Working Party on Lighting and Light Signalling (GRE)

Proposal for Supplement 16 to the 00 series of amendments to Regulation No. 77 (Parking lamps)

Submitted by the expert from Germany*

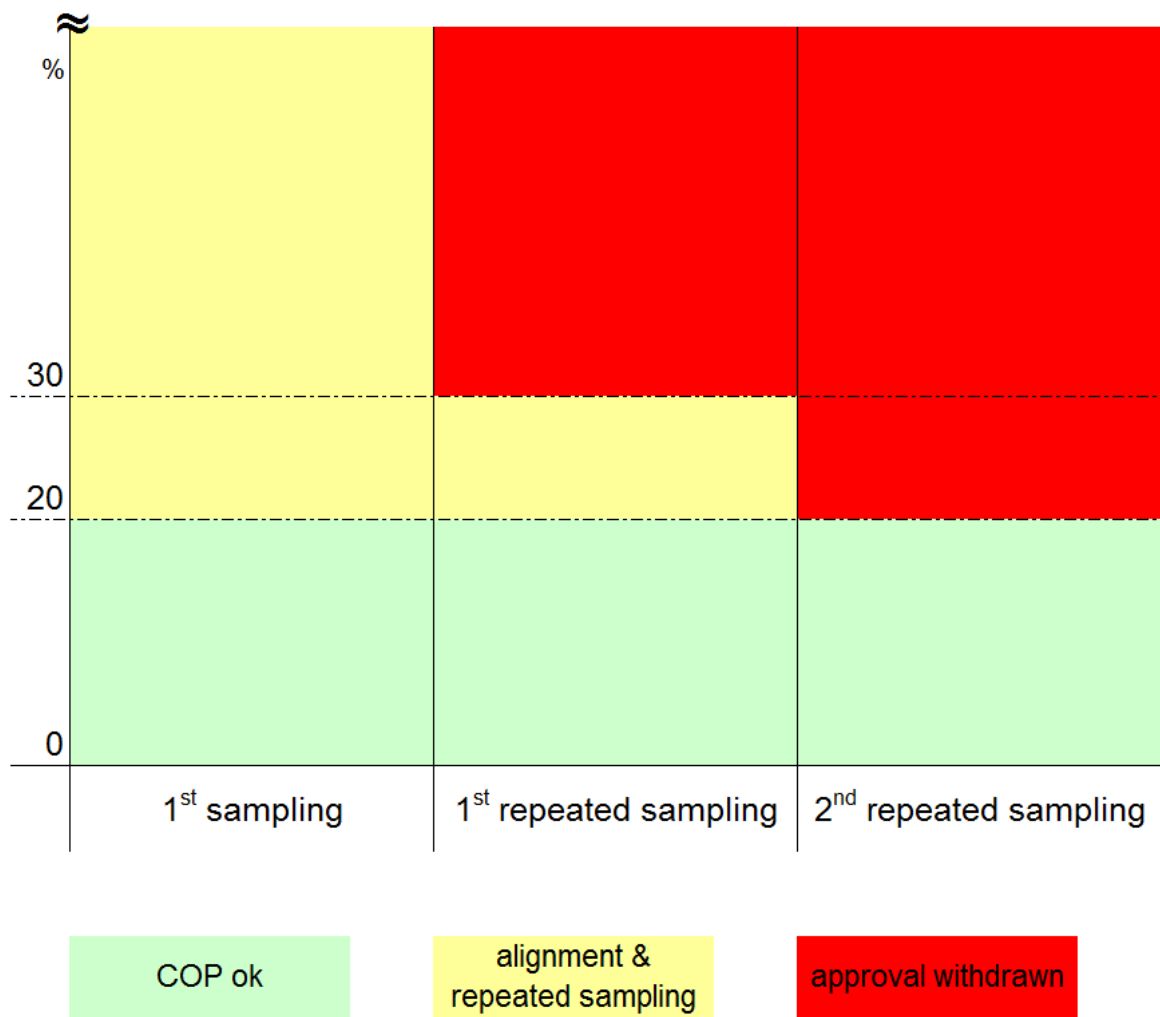
6. CoP is now described in a clear structured stepwise process (with limited steps), which gives the manufacturer the chance in the first step - in the case of deviations of more than 20 per cent - to align his production process. Also, the CoP process can be completed earlier when the first two samples are in the full specifications.

7. The proposal details the "third step" which defines the condition where the approval shall be withdrawn, when after the second repetition of this process the manufacturer was not in the position to "align" his production process in the correct way.

8. The attached drawing shall demonstrate this stepwise process.
